**March 9, 2021
5:30 P.M.
REGULAR MEETING
AGENDA**

Dear Norwalk Redevelopment Agency Chairman and Commissioners,
At the February 9th meeting of the Norwalk Redevelopment Agency, the Commissioners voted to table the review of 637 West Avenue in order to provide the application with an opportunity to reconsider their proposal to replace the existing portico with a two-story glass atrium. 637 West Avenue is listed on the local Norwalk Historic Resources Inventory List. Its most prominent feature is its existing two-story wood columned pediment, which mimics the design of the old City Hall building on Main Street.

Andriopoulos Design Associates was selected as the 3rd Party Design Reviewer to comment on the compliance of these proposed Façade Improvement with the Wall-West Neighborhood Design Guidelines. ADA previously recommended approving the proposed design for being compliant with the Wall-West Design Guidelines.

1
D2.00
PROPOSED NORTH ELEVATION LOOKING SOUTH EXTERIOR DEMOLITION ELEVATION
1/4" = 1'-0"

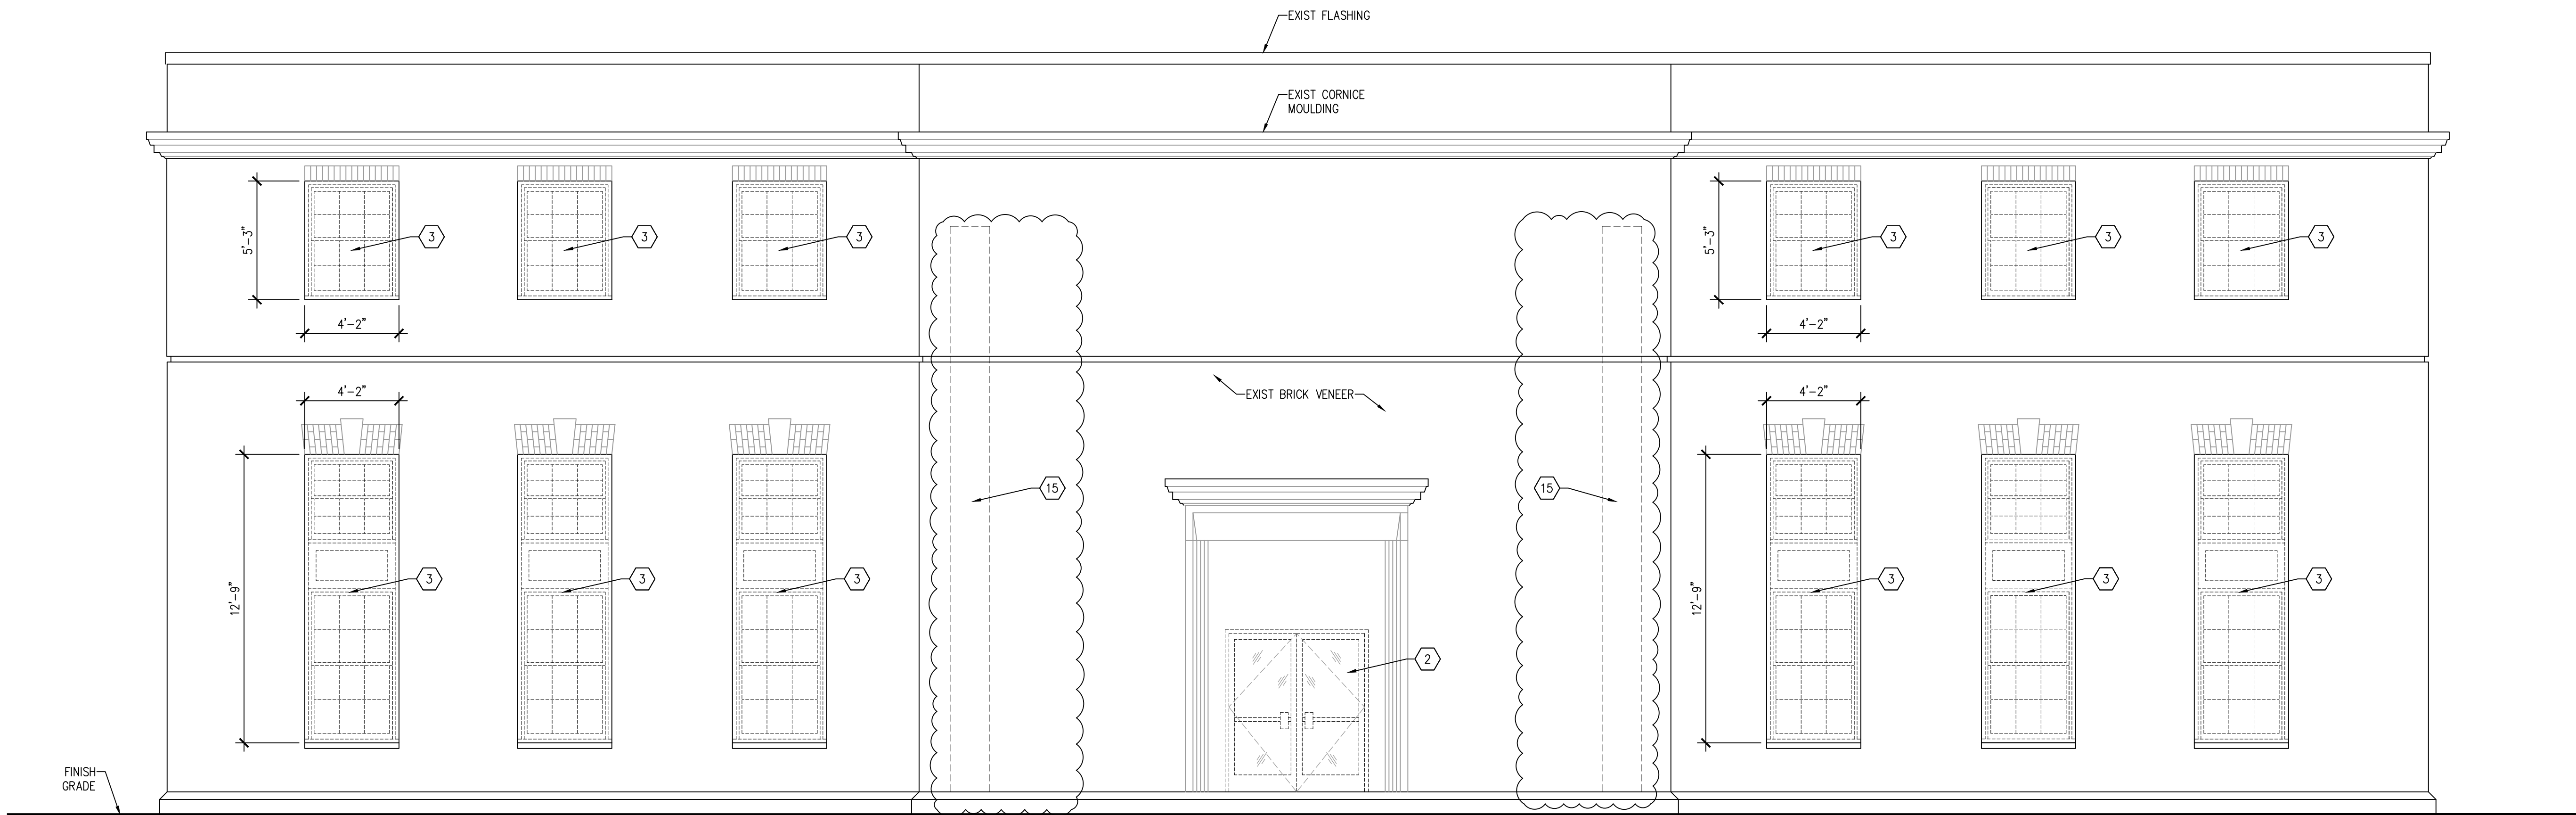
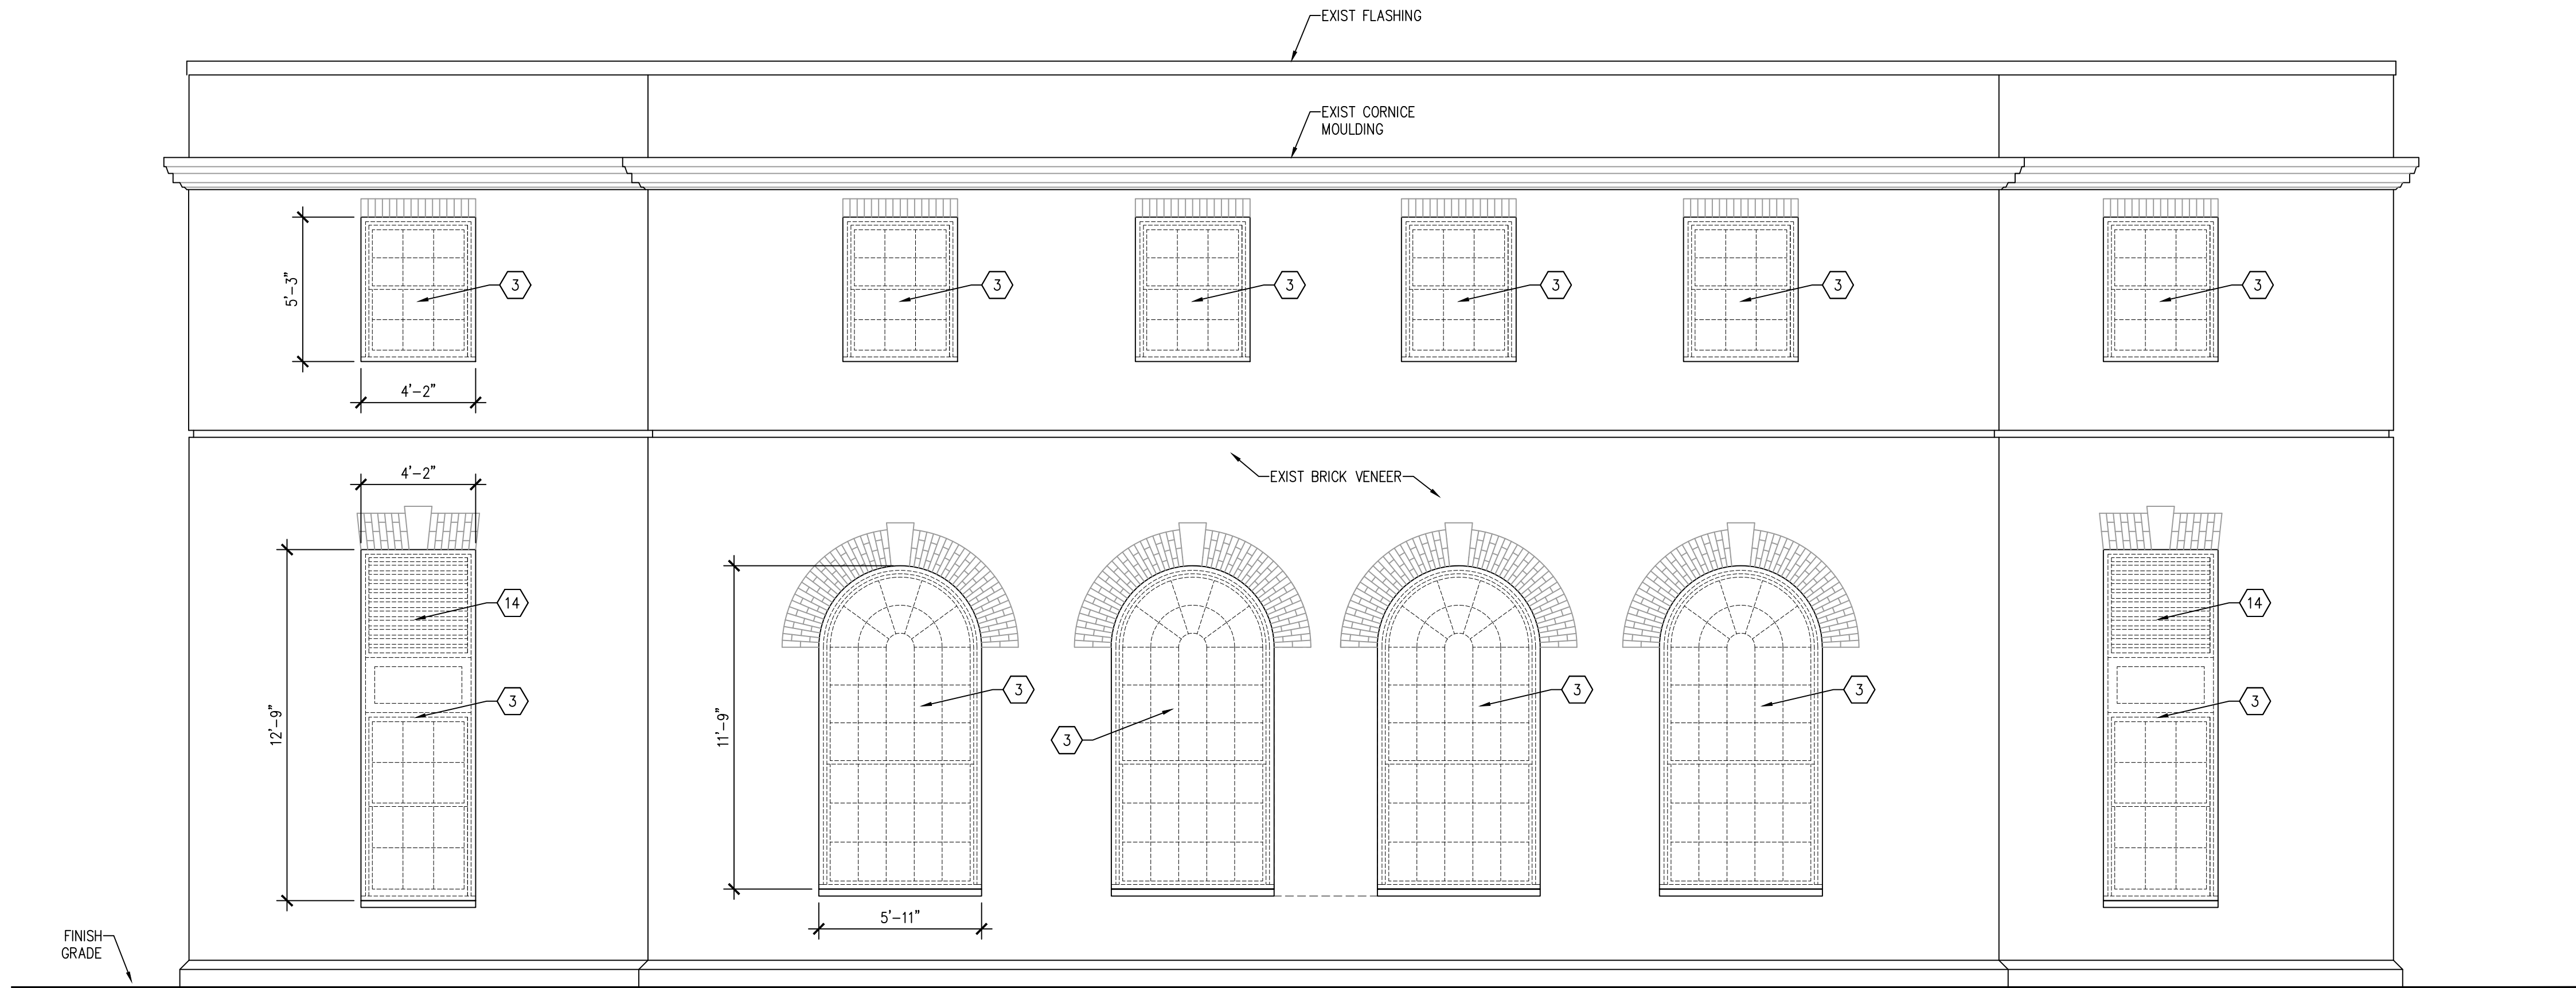
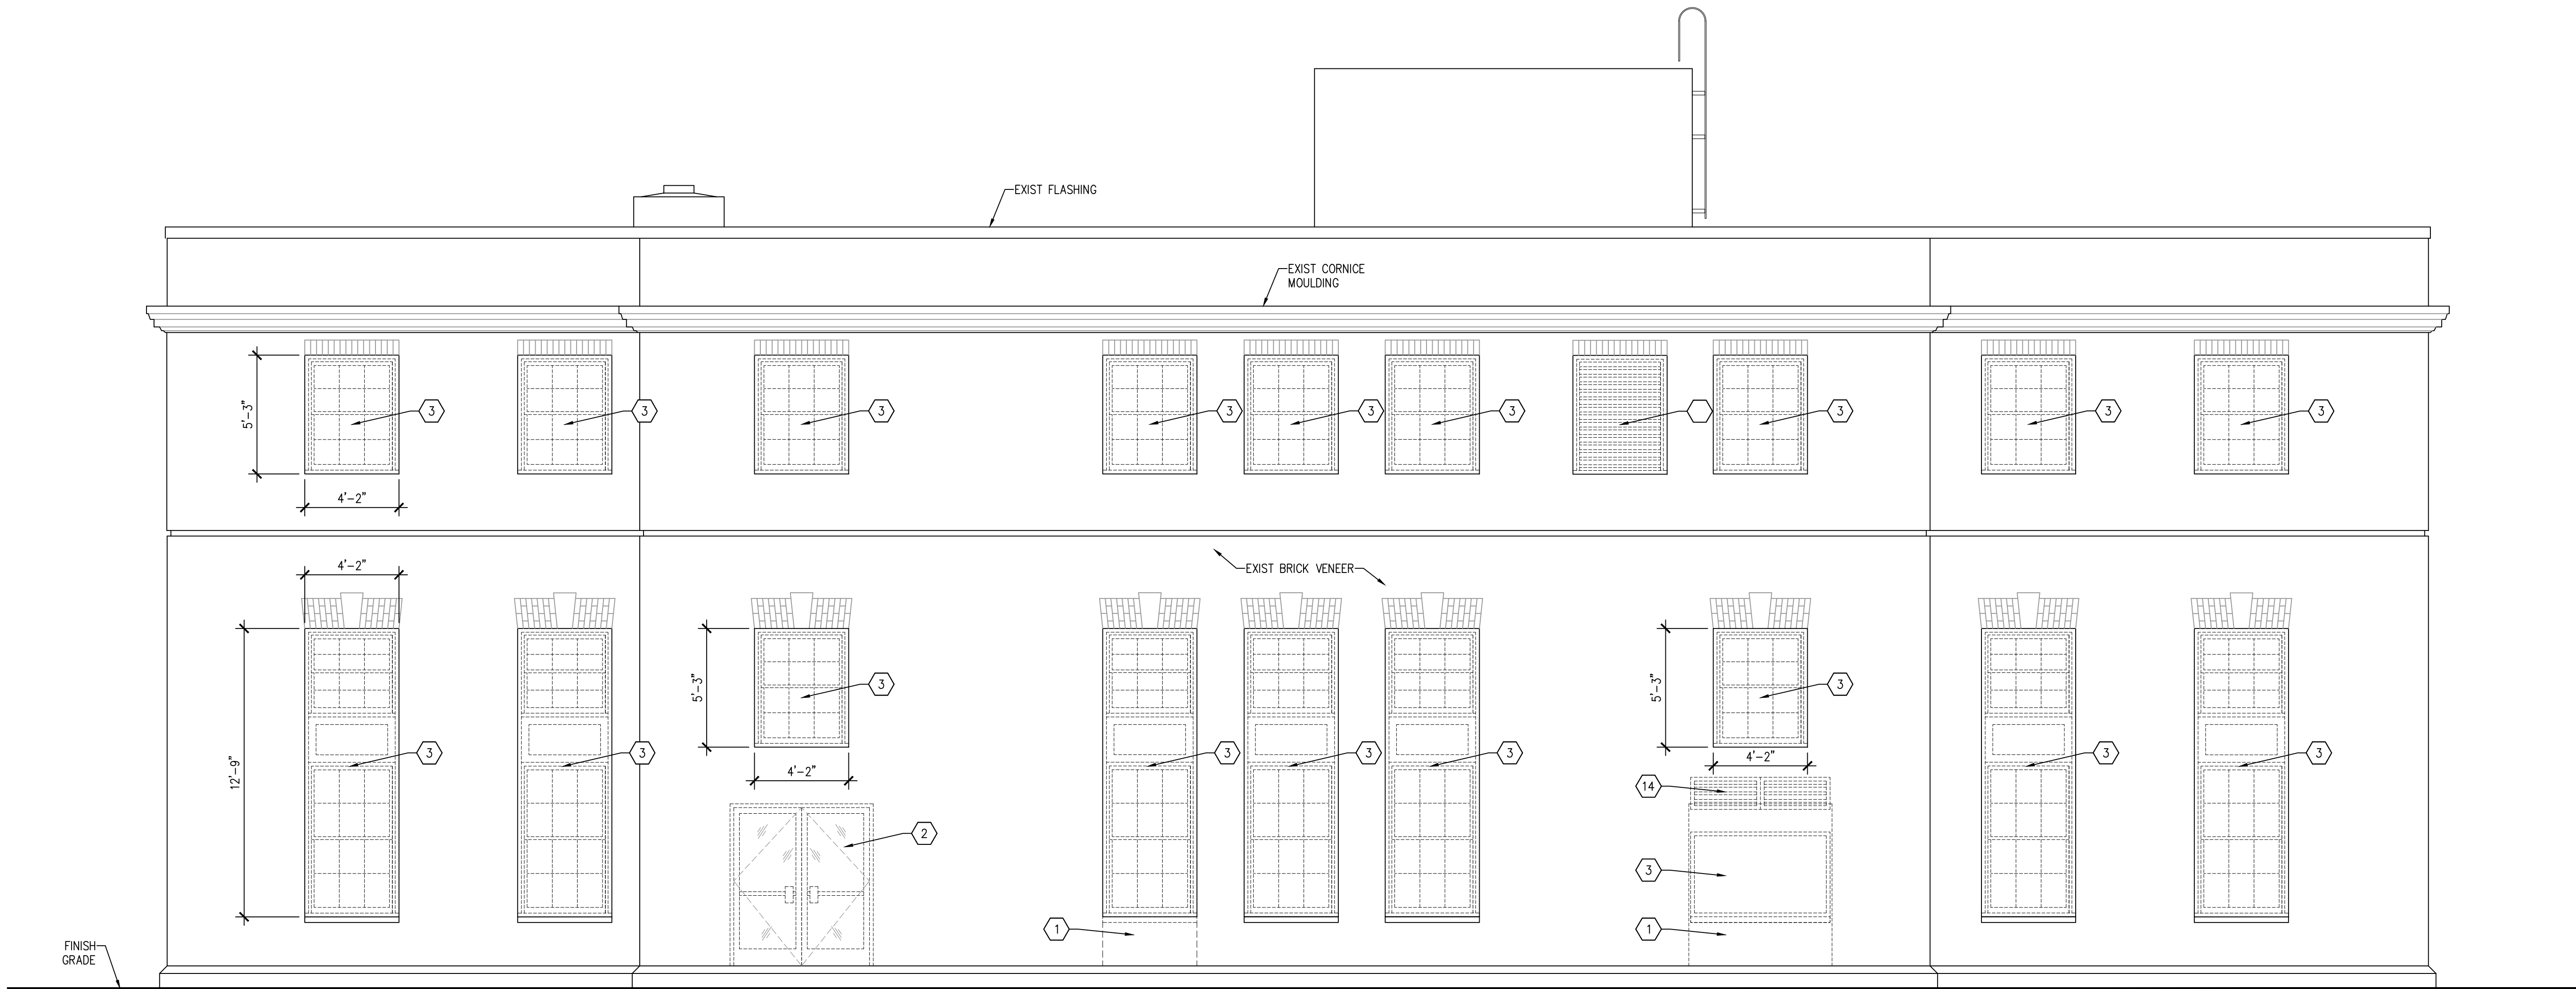
Mr. Westmoreland said that the removal of the front columns was a major change. He felt that the new design was a generic office box as opposed to the current portico and columns, which compliments St. Mary's Church next door. He added that with such a dramatic change, the Board may wish to table this for a month to allow for public comment since he did not think that people were aware of the proposed changes. Discussion followed.

- Retention of the existing front portico;
- New exterior lighting, site paving, and canopies;
- Installation of two new exterior doors on either side of the main entryway;
- Removal of a drive-thru window and rebuilding of the window opening and brick wall;
- Installation of new doors and windows throughout; and
- Creation of a new rooftop mechanical structure.
